**Comment Supplement on IEEE 802.3av D2.0**

**Modification Version on Subclause 75.8**

**Jitter at TP1-TP8 for PR10, PR20, PR30,  
PRX10, PRX20, PRX30 (\*informative)**

**Shanghai Luster Teraband Photonics Co., Ltd**

Figure 75-11—Jitter gain curve values for PR10, PR20, PR30, PRX10, PRX20, PRX30

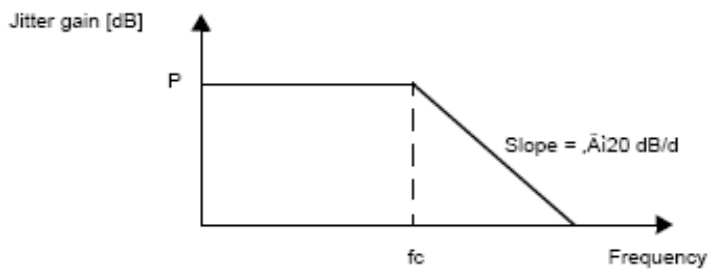
The upstream jitter transfer function is defined by Equation 75-1. The jitter gain curve and the corresponding jitter gain values are shown in Figure 75-11 where the jitter gain P and the jitter corner frequency fc are specified in Table 75-17 for PR10, PR20, PR30 and in Table 75-18 for PRX10, PRX20, PRX30 respectively.
